Access Compliance Report Public Rights-of-Way (Curb Ramps)

Main Street: O_NEILL_DR Cross Street: NARROW_CANYON_RD Location: NE

ADA ID: RPRK211103151621 Ramp Type: Type 4 - Parallel Initial Pass/Fail: Pass Overall Compliance: No Severity Score: 15

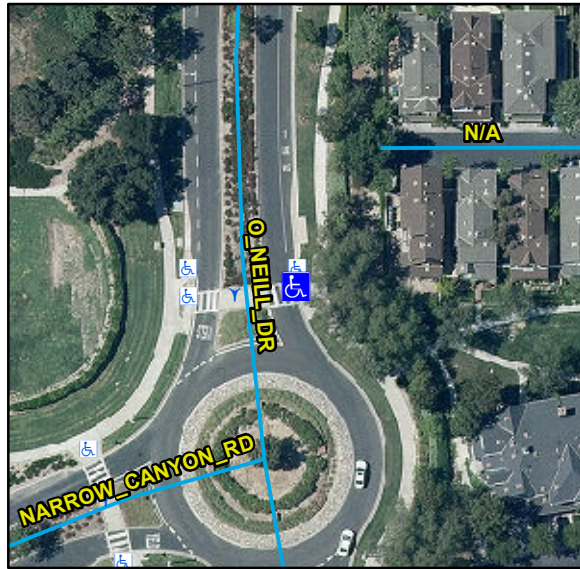
R304.2.1, R305, R304.5.4, R304.5.3, STD 1115

Yes	Ramp Inside Crosswalk 1	Yes	N/A	Ramp Inside Crosswalk 2	N/A
	Crossing 1 Slope (%)	1.1		Crossing 2 Slope (%)	N/A
	Crossing 1 Cross Slope (%)	2		Crossing 2 Cross Slope (%)	N/A
Yes	Gutter Ponding	No	Yes	Curb Slope	7.6
Yes	Gutter Lip Height (in)	0		Road Run Slope (%)	N/A
No	Gutter Run Slope (%)	5.8		Road Cross Slope (%)	N/A
No	Gutter Cross Slope (%)	2.7	Yes	Perpendicular Joint Present	Yes
Yes	Overall Surface Condition	Acceptable			
	Cross Gutter Present?	No		Spandrel Present?	No
	Replace Cross Gutter?	N/A		Replace Spandrel?	N/A

Remove & Replace Entire Ramp. Remove & Replace Gutter.
